May 22, 2018

**Re: SPLP Response to Comments
Hydrogeological Reevaluation Report
Arch Bishop/South Chester Road HDD (S3-0541)
DEP Permit Nos. E15-862 and E23-524
Westtown and Edgemont Townships
Chester and Delaware Counties, Pennsylvania**

ATTACHMENT 2
WATER SUPPLY ILLUSTRATION

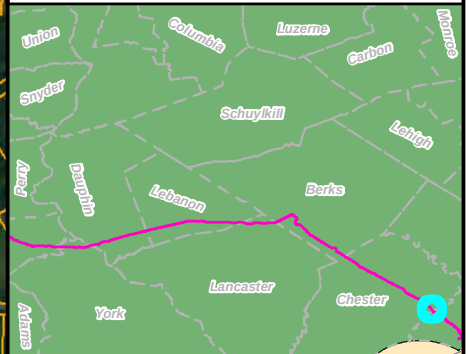
b. A map showing all the private water supplies in the correct, surveyed locations.

The water supply illustration provided as Attachment 2 to this response is an accurate presentation of the known water supply wells. The well locations were recorded by GPS.

HDD PROFILES WITH WELL LOCATIONS, WATER LEVELS, AND FRACTURE TRACE LINES

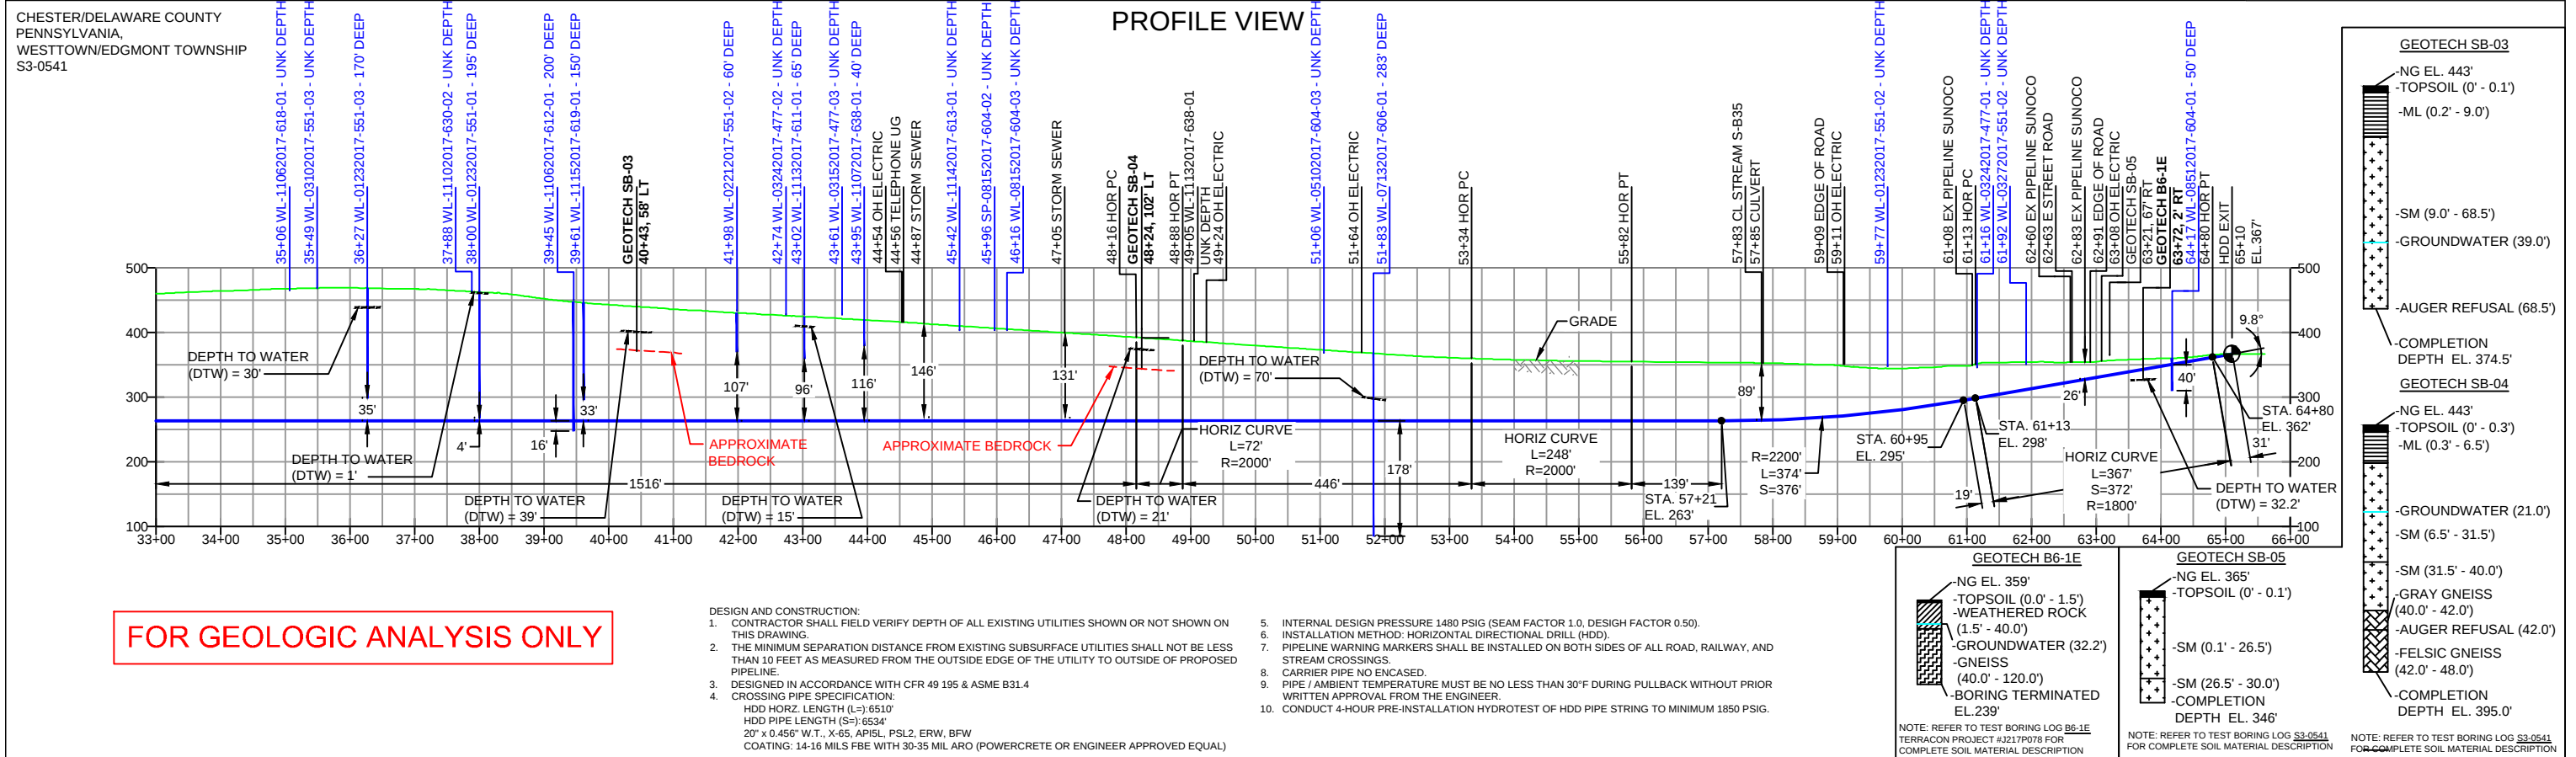
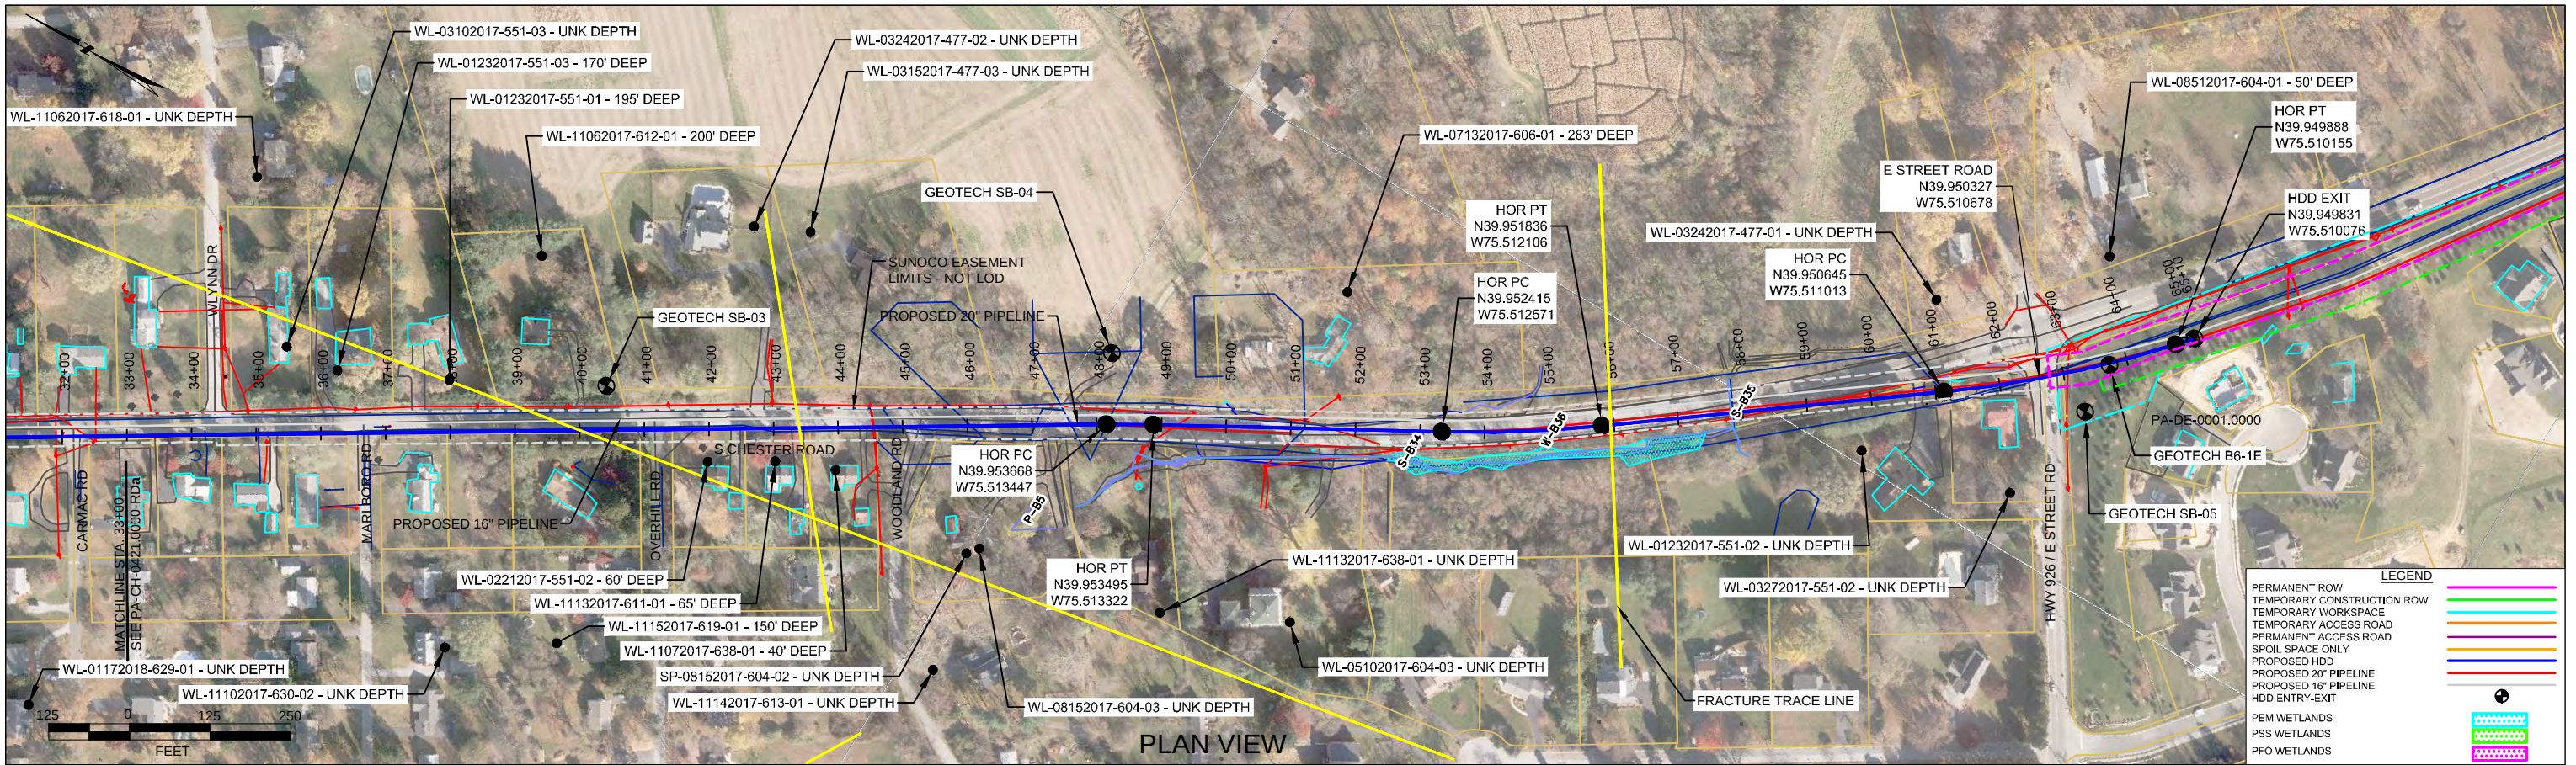
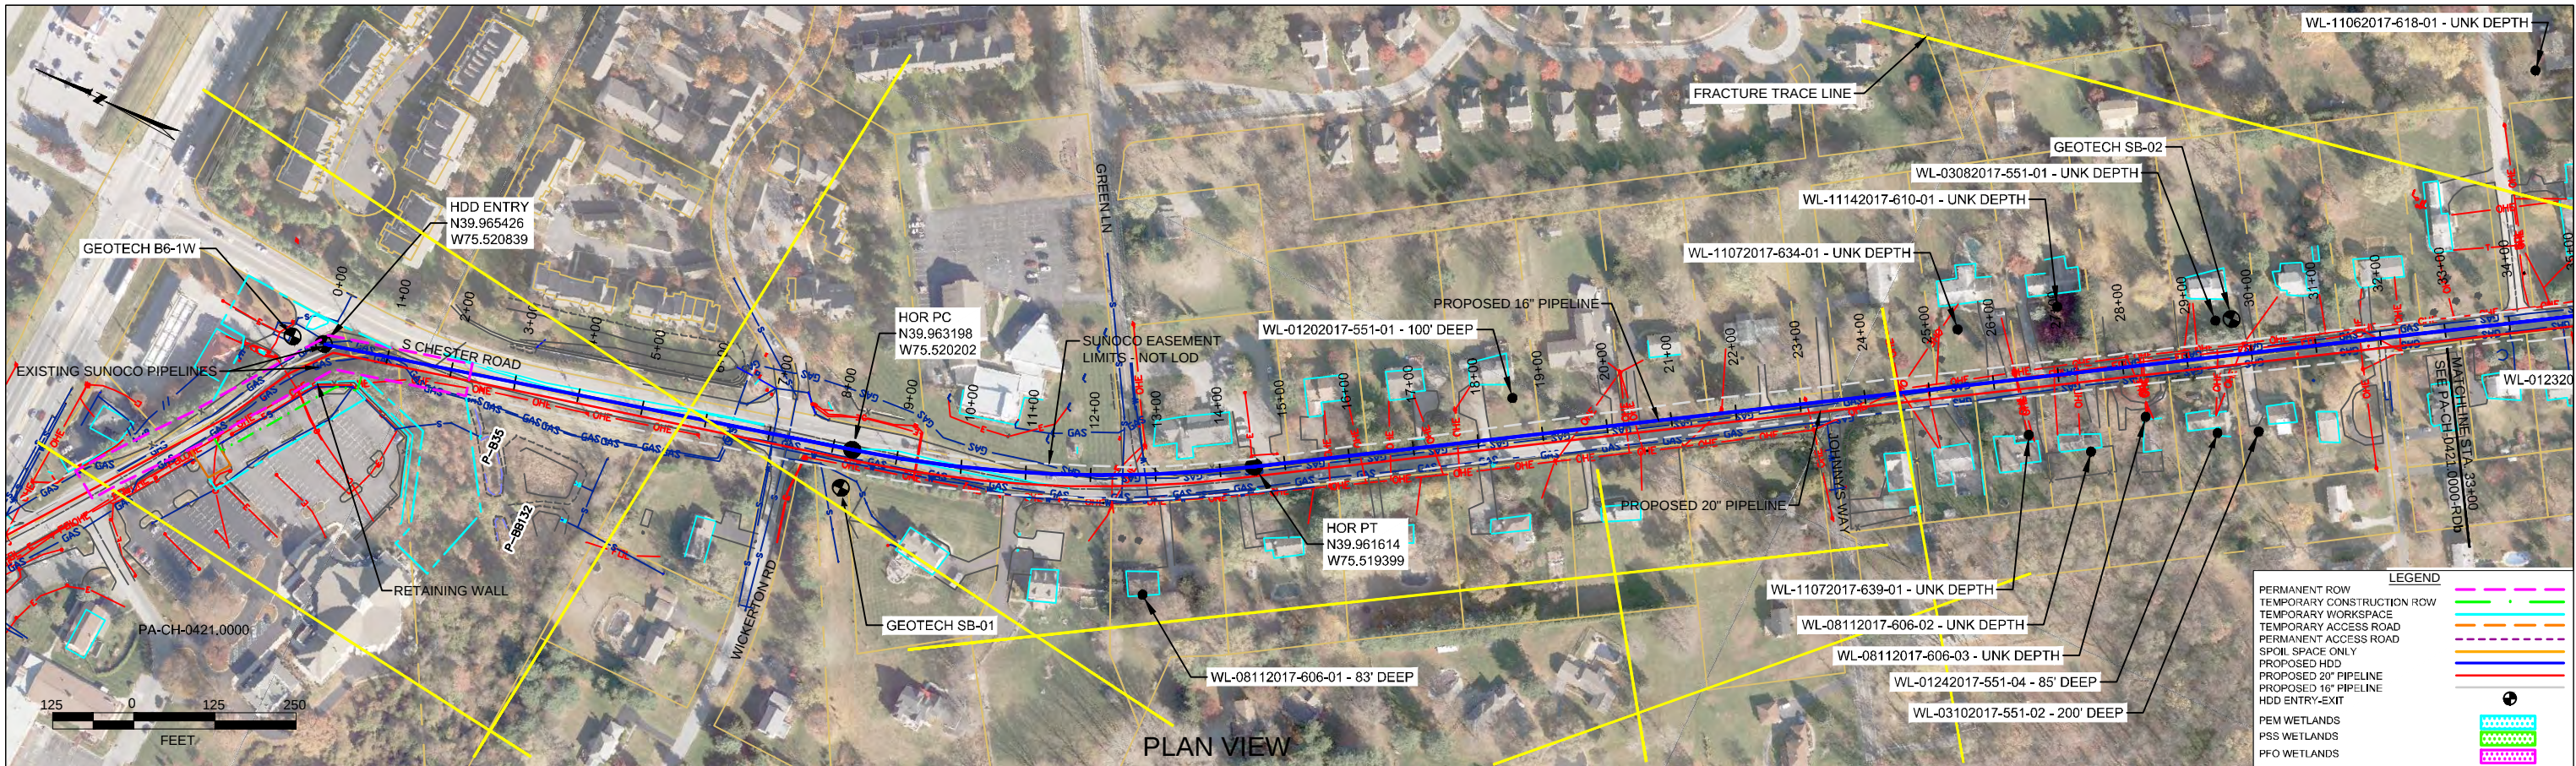
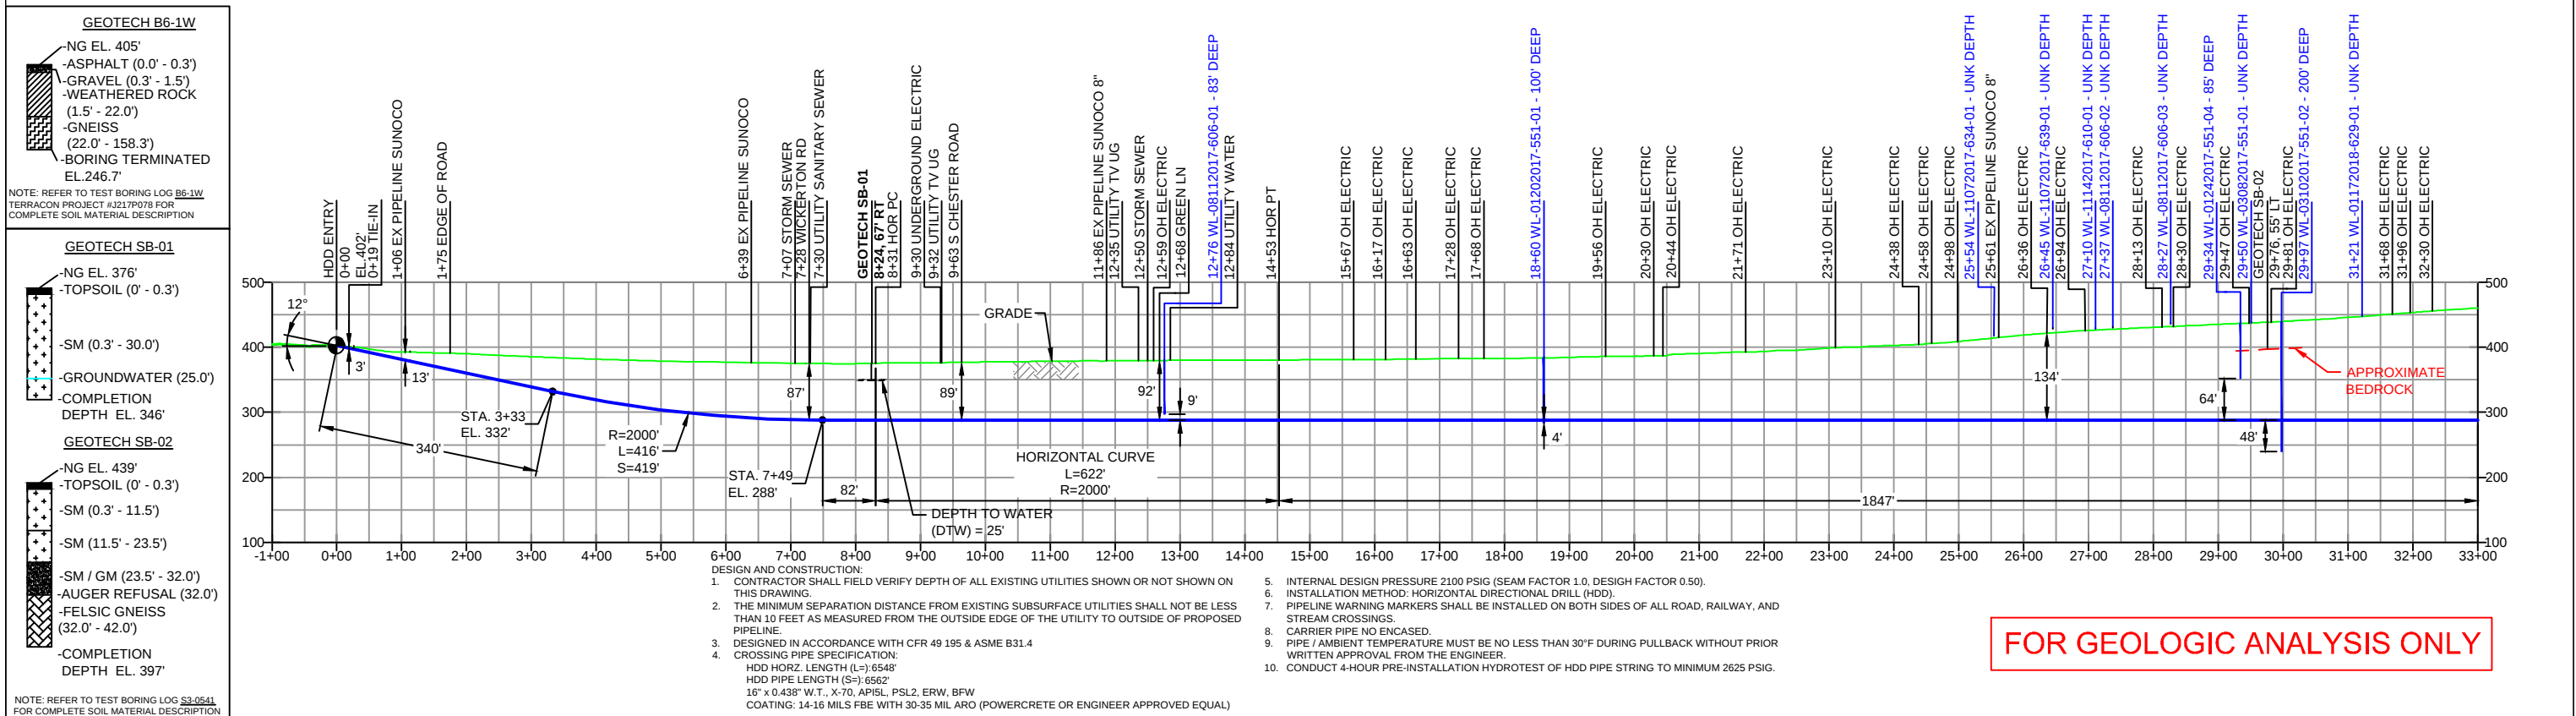
6. There are reported intersections of fracture traces with the planned HDD bore path within close proximity to residential supply wells. The HDD alignment crosses six fracture traces mapped as part of reevaluation, but these fracture traces are not discussed as they relate to well locations and proximity to bore path. Further discuss these fracture traces, map them on present day aerial photos, evaluate them for potential problem areas, and provide this information, including the results of the evaluation, to DEP.

- b. Project water wells depths, casing depths and water-level depths (based on a water-level survey) on cross sections/profile views.**

- c. Identify zones of fractures or fracture trace intercepts on the profile views, along with residential water supply well locations.**

A plot of the approximate fracture traces on the HDD profile (see **Attachment 4**) indicates that several residential wells in the 450-foot sampling program may lie on or near a potential fracture. The fracture trace locations were derived from stereographic imagery using aerial photographs from 1943, and then transposed on current aerial maps; thus, a small degree of error in plotting accuracy exists, and the fracture trace locations are described as “approximate.” Fracture traces are the surface representation of vertical to near vertical planar zones of fracture concentration, thus a well would have to be very close to a fracture trace to be intersected by it. The wells which are closest to fracture traces are from 54 to approximately 500 feet from the HDD borepath, occurring between Stations 35+00 to 45+00 as shown on the HDD profiles. The use of Aquabloc will mitigate the travel of groundwater through fractures, and of drilling fluids away from the bore path. SPLP will follow the Operations Plan and Water Supply Plan, by adhering to the notification, sampling, and monitoring procedures outlined therein, to ensure all affected residents will have potable drinking water. (Also see answer to 5(a).)

Attachment 4 presents a set of the HDD profiles with water well depths and water levels if known represented in the cross-section view.

The set of HDD profiles in Attachment 4 has the fracture trace intercepts included on the plan view.
